THE FIELDS AT SOUTHPOINTE

FINAL DEVELOPMENT PLAN

**Community Development Department
Plan Review
513-524-5204**

L1.0

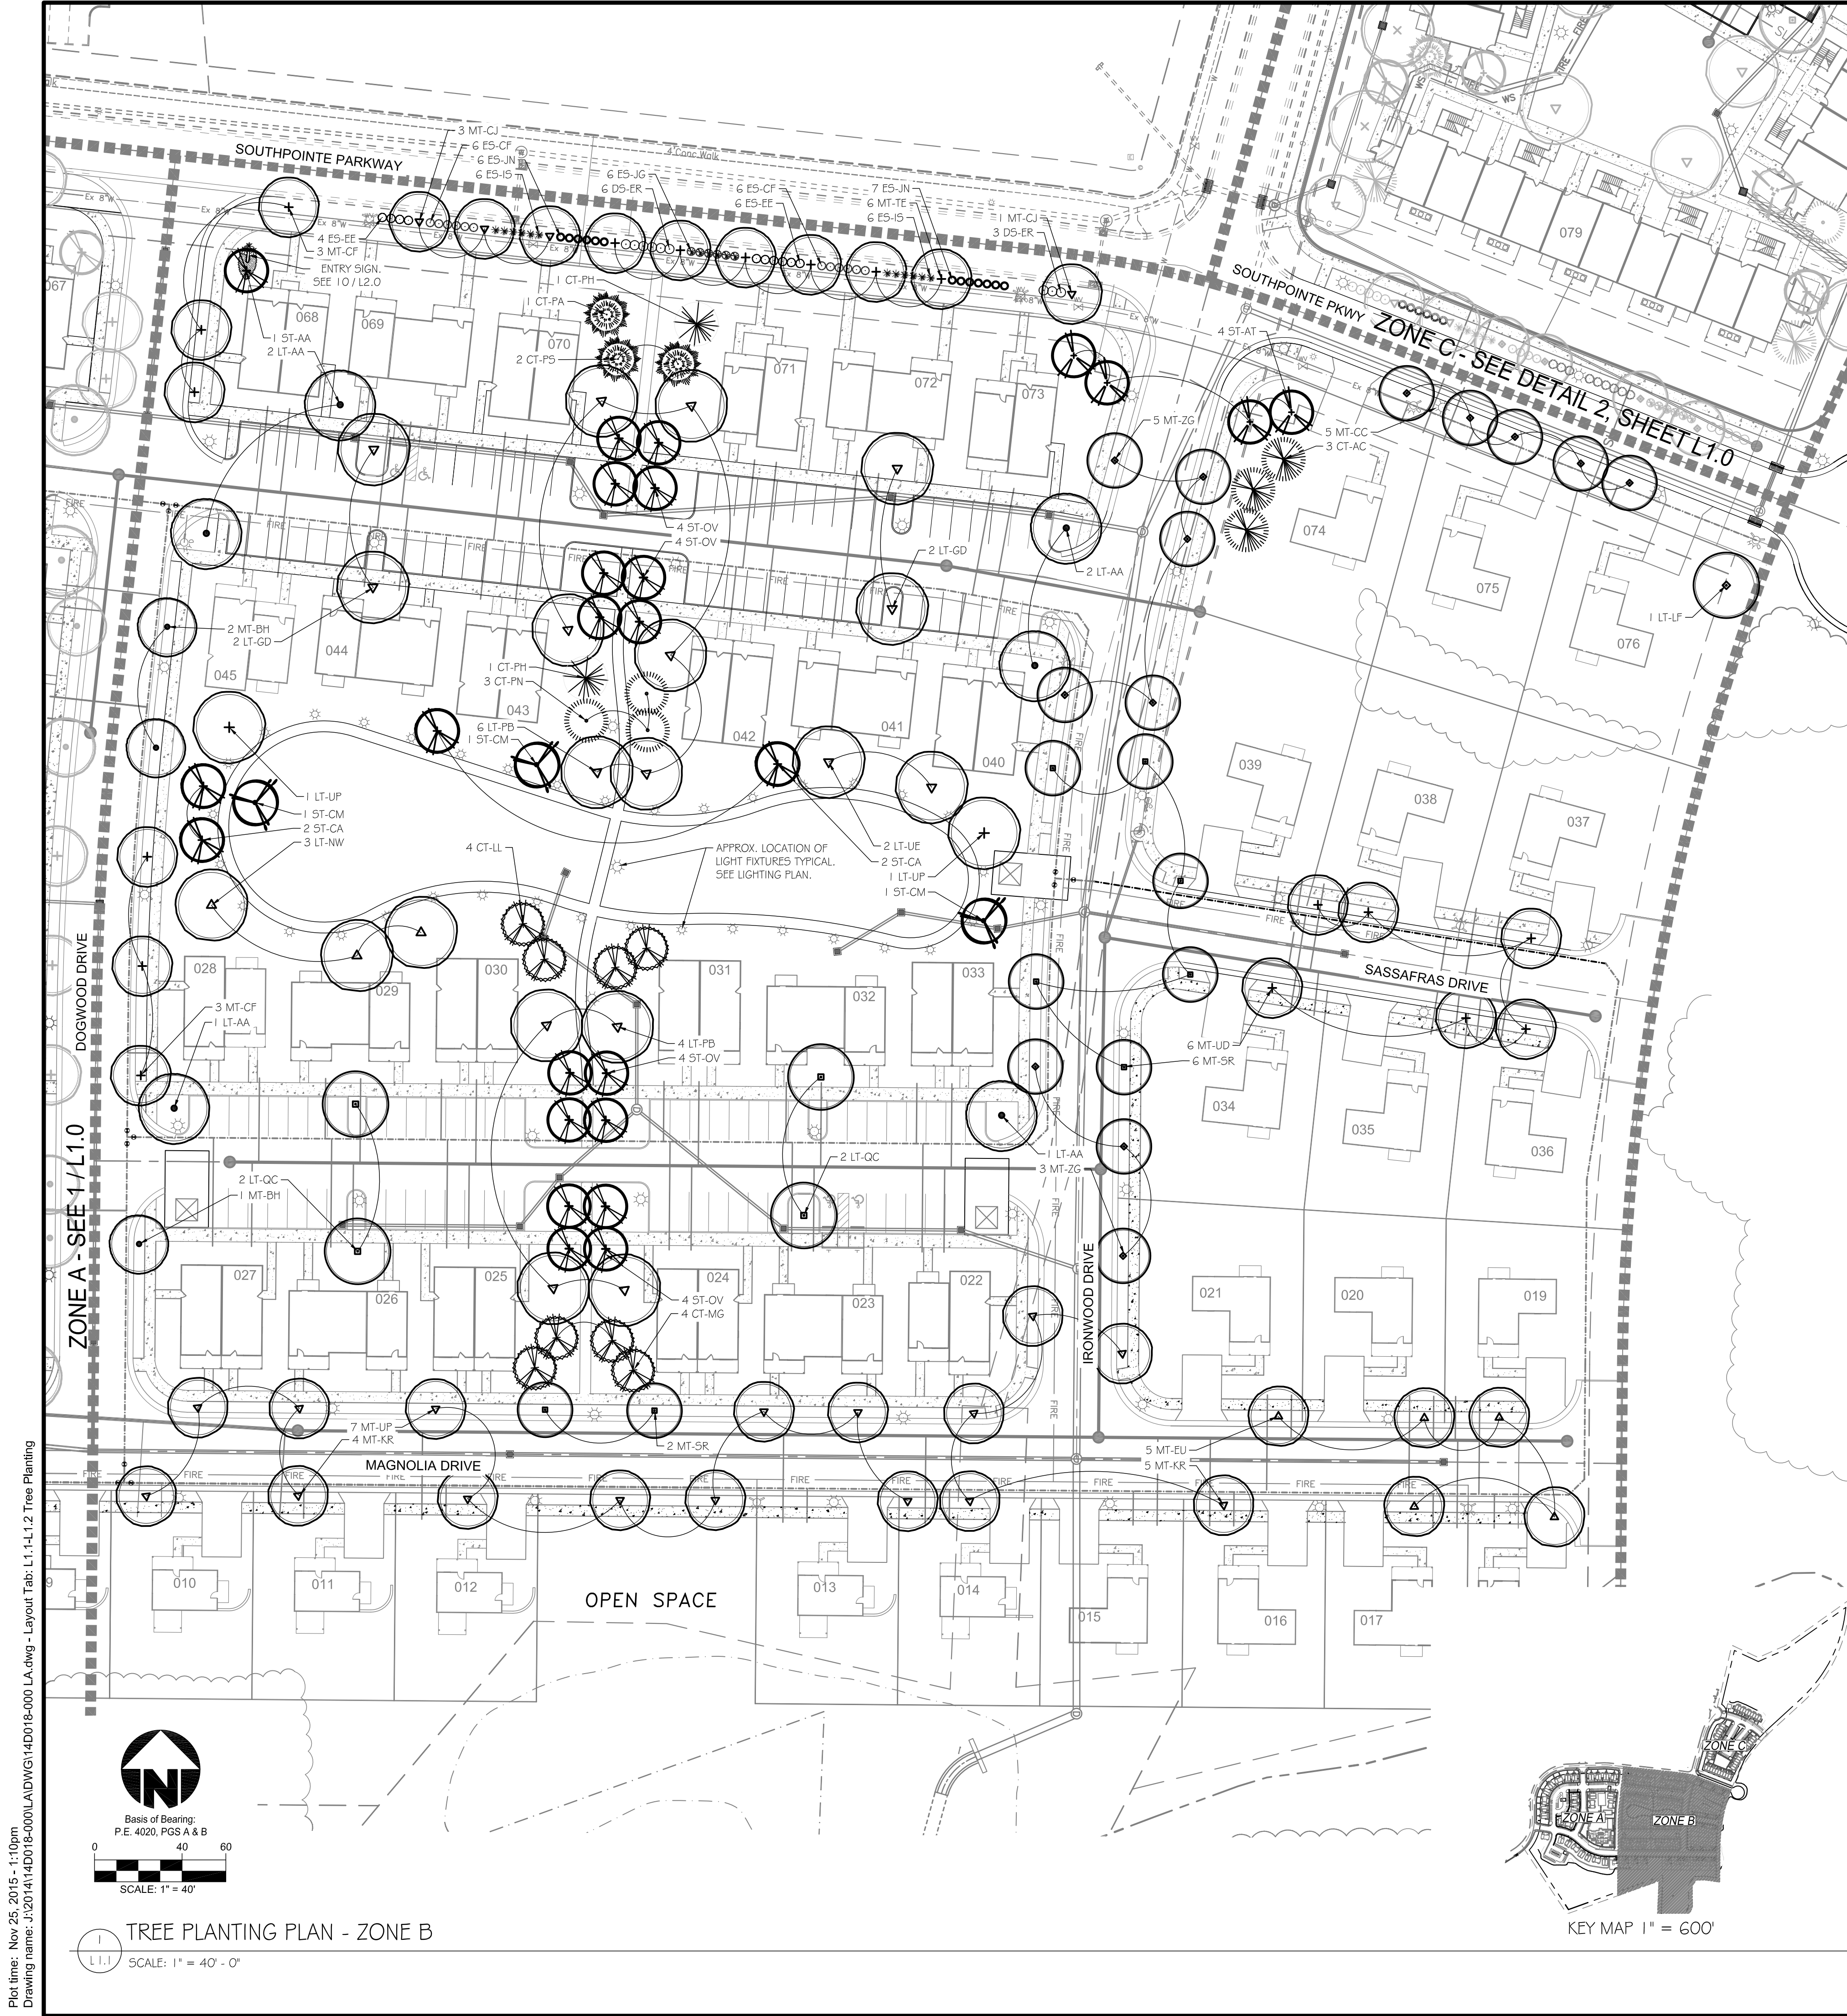
- L1.0
 - Are shrubs allowed in the treelawn along Southpointe Parkway?
 - Omit tree plantings in the townhouse open space and leave natural mature trees?

Review of the Tree Planting Plans (Sheets L1.1 and L1.2, dated November 25, 2015) indicated some 357 individual shade, ornamental, and conifer trees are posed, including 43 different Species from 32 Genus. The proposed plantings will satisfy the pending revision to Oxford Codified Ordinance Chapter 935.05 (Street Tree Species to be Planted) suggested by the Environmental Commission, Oxford's Tree Authority.

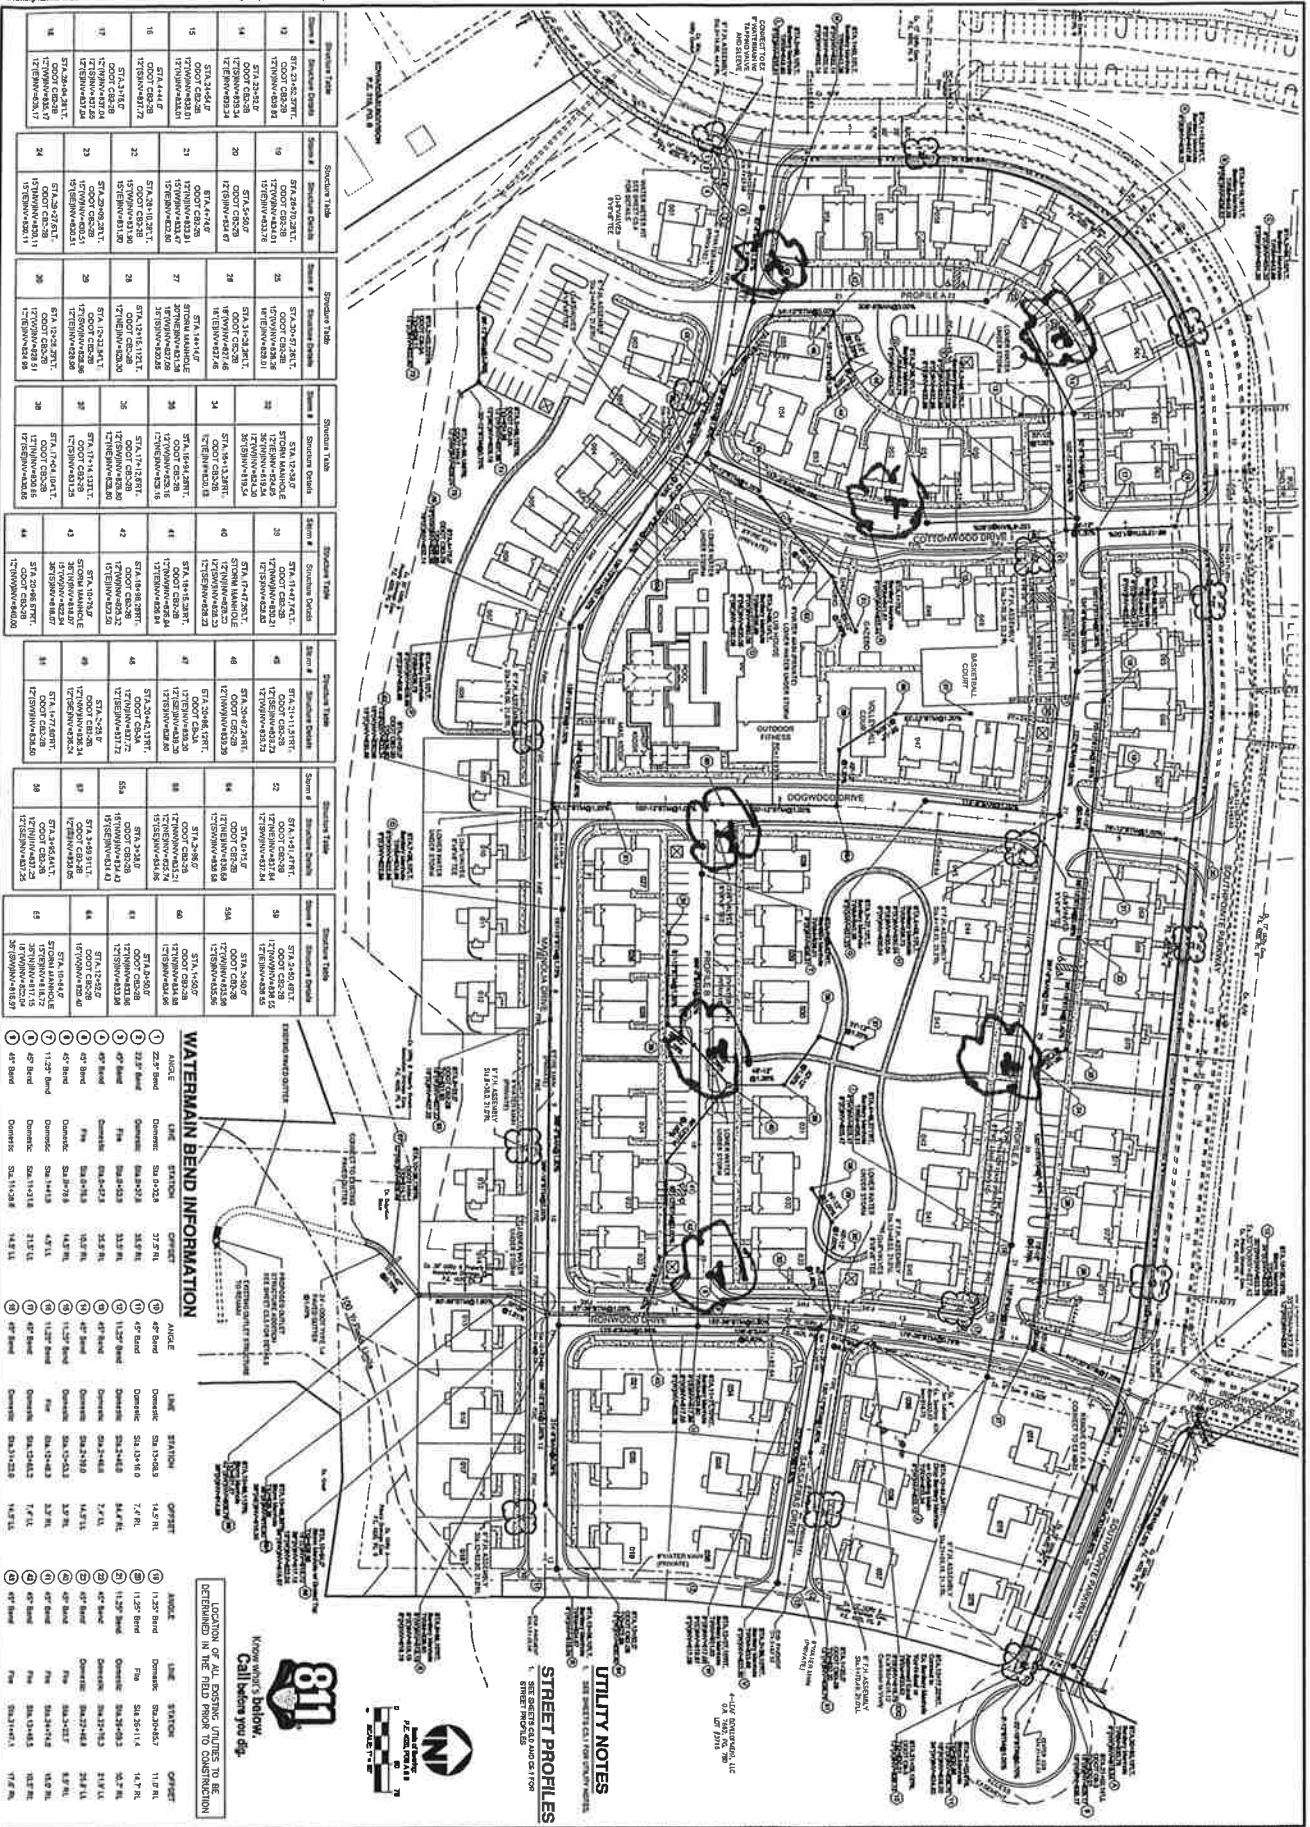
Etta,
After looking at the hydrant locations there is one on sheet C5.1 that needs to be relocated and several additions on sheet C5.2 due to locations and distances. These are noted in blue on the attached pages.
